FORM VT-3C
CONTAINMENT INSERVICE INSPECTION
RECORD OF VT-3C EXAMINATION

STATION/UNIT: Indian Point 2 COMPONENT NO.: VCC-21
 ZONE NUMBER: IWL-108-004 DRAWING NO.: 320855
 EQUIPMENT USED: Celestron Giant 20x80 Binoculars (Ser. No. 990176)

CONCRETE INSPECTION ZONE IWL-108-004
 (EXTERIOR DEVELOPED VIEW, LOOKING FROM OUTSIDE)

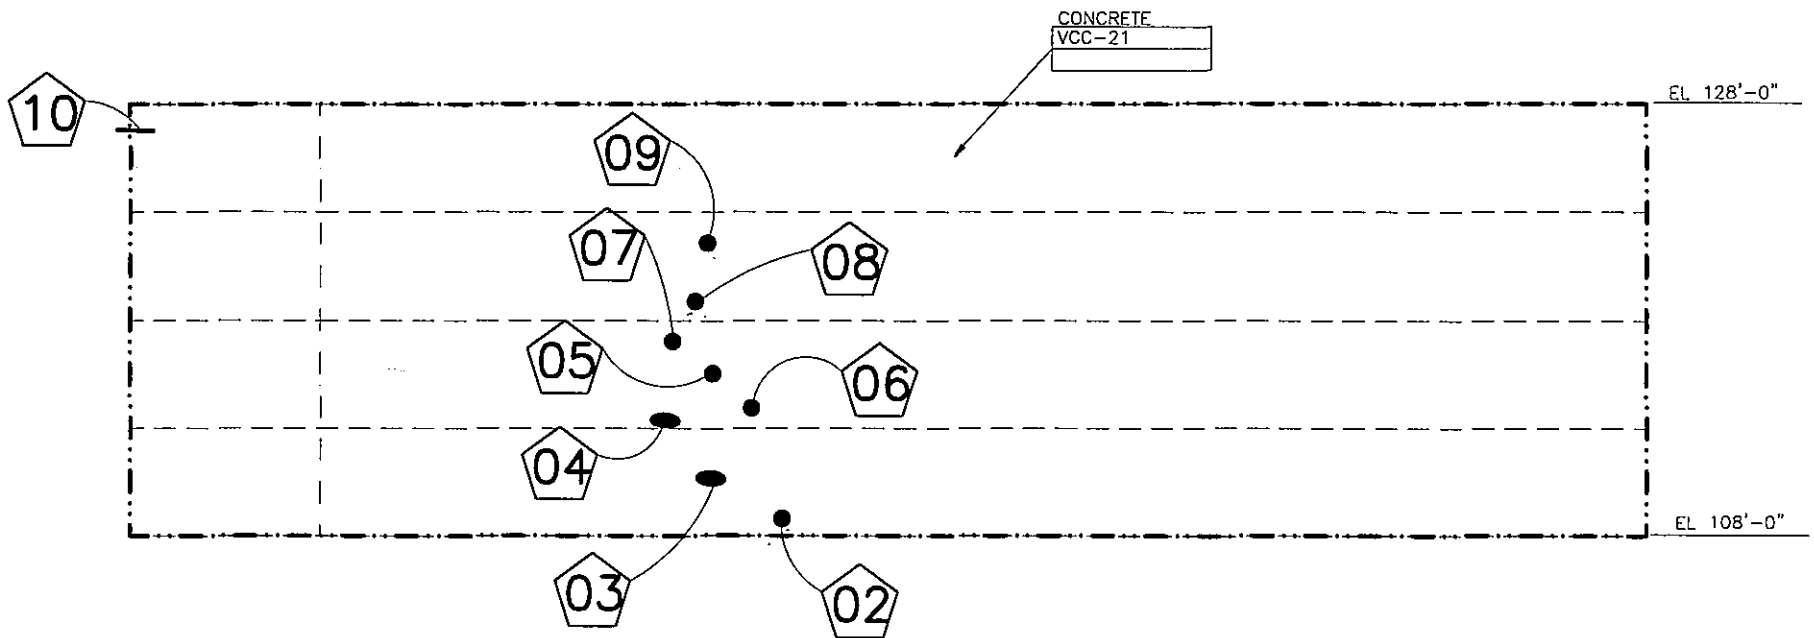
| No. | Comment | Initials |
|-----|--|----------|
| 2 | 1 1/2" rebar exposed due to spall. See photo 00052618 | RN |
| 3 | Concrete spall, 8" concrete about to popout. See photo 00052618 | RN |
| 4 | 10"x4" concrete spall exposing rebar over 8" length. See photo 00052619 | RN |
| 5 | 2" concrete spall. See photo 00052621 | RN |
| 6 | 6" concrete about to spall. See photo 00052621 | RN |
| 7 | same as item 6. See photo 00052621 | RN |
| 8 | rebar (rusty) exposed at 2 locations spaced 9". See photo 00052622 | RN |
| 9 | 2" hole exposing rebar. See photo 00052622 | RN |
| 10 | 1/2" cover concrete spalled off over 10" square exposing 9" length of cadweld sleeve. See photo 00052623 | RN |

Comments: The surface texture (comment #1) resulted from original construction and does not reflect degradation. Engineering evaluation is needed for all of the other observed conditions.

CONCRETE INSPECTION ZONE IWL-128-001
(EXTERIOR DEVELOPED VIEW, LOOKING FROM OUTSIDE)

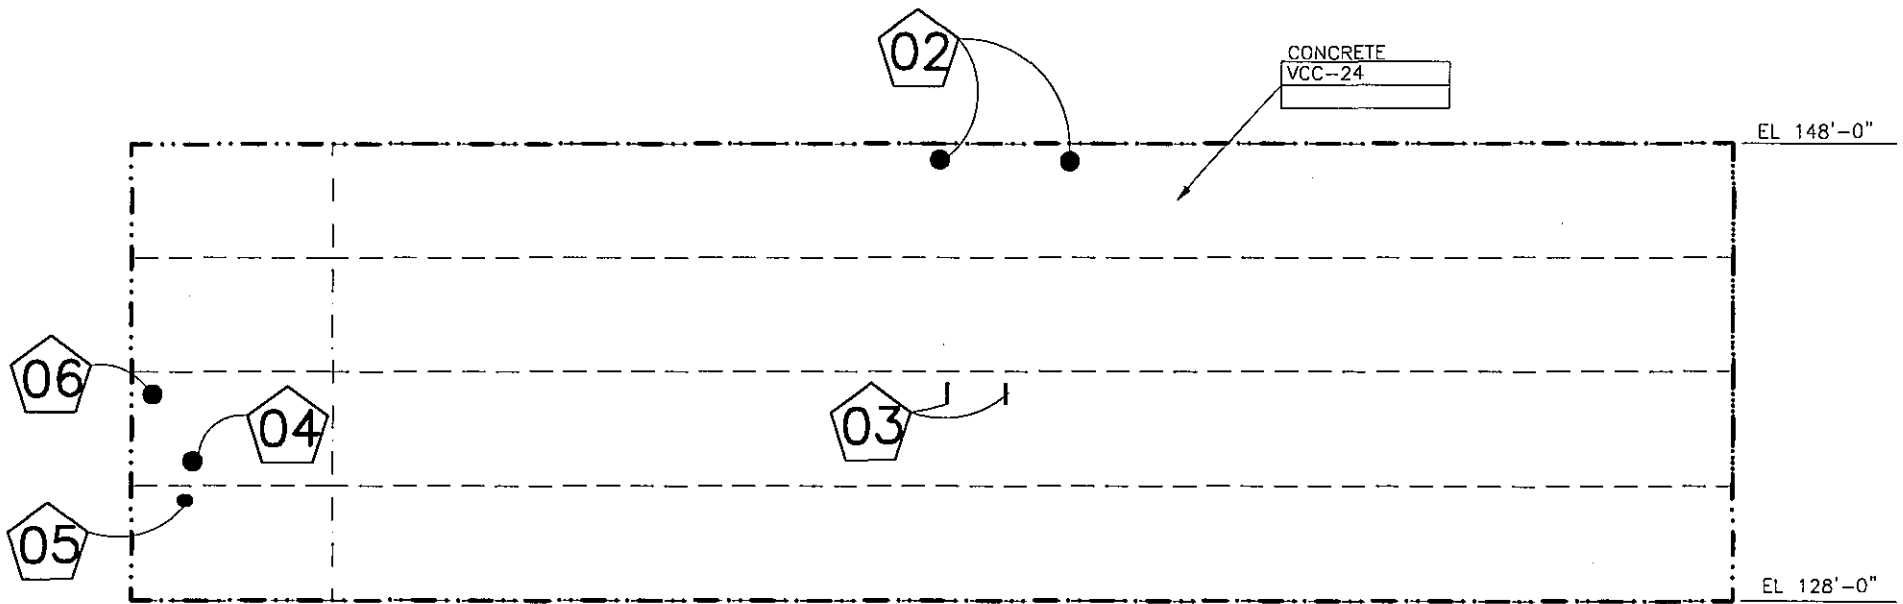
| No. | Comment | Initials |
|-----|--|----------|
| 2 | minor leaching from construction joints - 2 places | RW |
| 3 | same as in item 2 | RW |
| 4 | 6" of mortar about to spall. See photo 00052602 | RW |
| 5 | Rust stain on concrete below, from exposed cadweld sleeve with rust over 6" length. Inadequate concrete (about 1/2") cover. See photo 00052601. | RW |
| 6 | 1" deep hole created in concrete cover by inadequate consolidation during pouring exposing 2" of reinforcing steel. See photo 00052603 | RW |

Comments: The leaching is not significant. The surface texture resulted from original construction and does not reflect degradation of the containment. Engineering evaluation is needed for the spalling/corrosion associated with the reinforcing steel (comment nos. 4, 5 & 6).

CONCRETE INSPECTION ZONE IWL-128-002
 (EXTERIOR DEVELOPED VIEW, LOOKING FROM OUTSIDE)

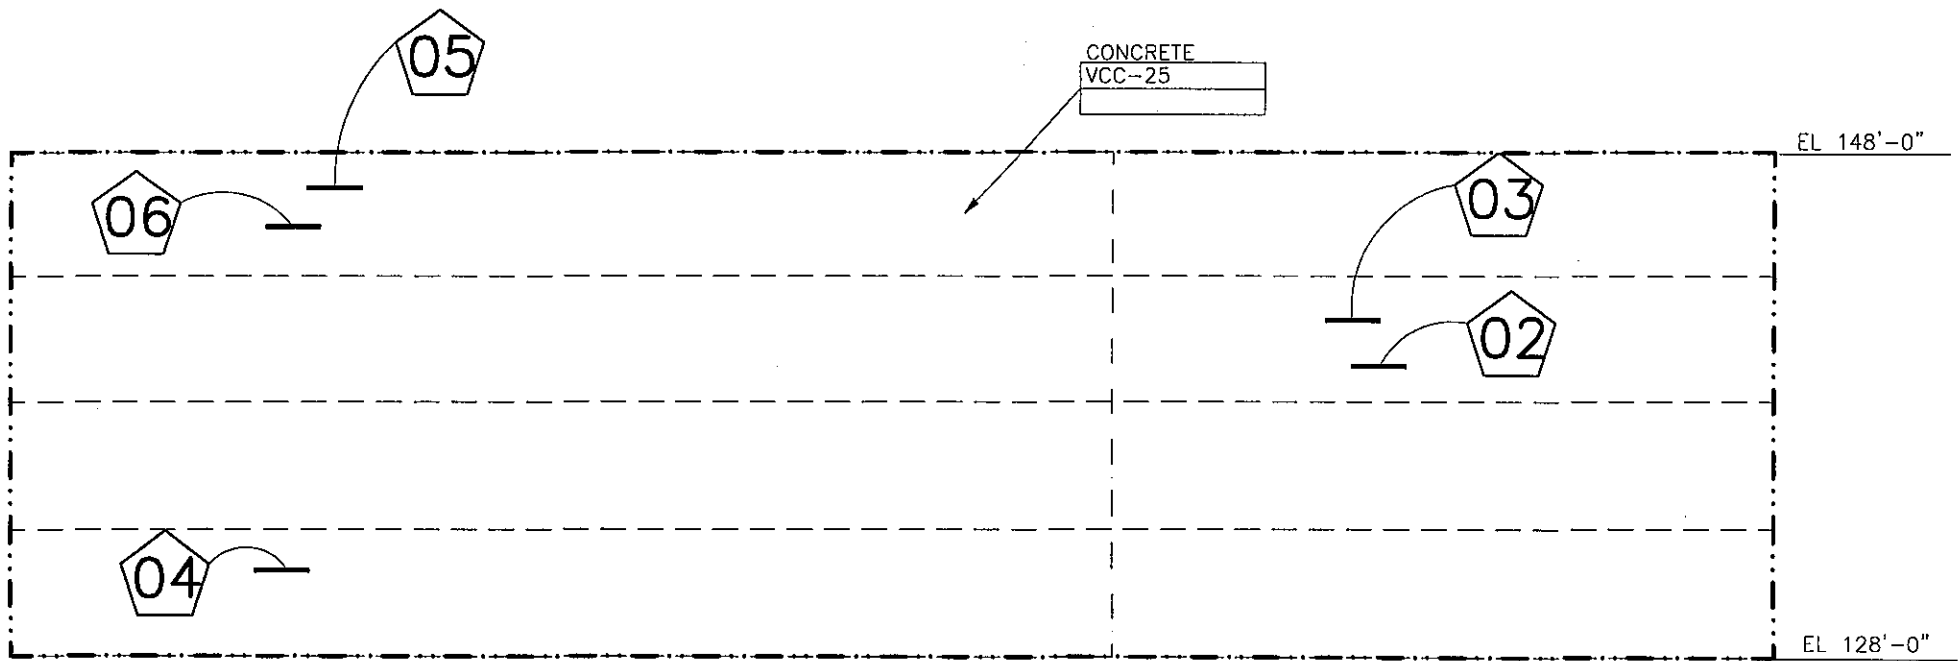
| No. | Comment | Initials |
|-----|--|----------|
| 2 | Cadweld exposed & corroded due to loss of concrete cover. See photos 00053136 and 00053139 | CAS |
| 3 | Cadweld exposed & corroded due to loss of concrete cover. See photo 00053137 00053139 | CAS |
| 4 | Cadweld exposed & corroded due to loss of concrete cover. See photo 00060119 | CAS |
| 5 | A small area of concrete has cracked and is likely to spall off. By comparison to other similar areas it is believed to be a cadweld or reinforcing steel which is corroded due to insufficient concrete cover. See photo 00053150 | CAS |
| 6 | The concrete has cracked & bulged in a small area that is likely to spall off. By comparison to other similar areas it is believed to be a cadweld or reinforcing steel which is corroded due to insufficient concrete cover. See photo 00053150 | CAS |

Comments: The surface texture (comment #1) resulted from original construction and does not reflect degradation of the containment. Engineering evaluation is needed for the spalling/exposed reinforcing steel (comments #2-#6).
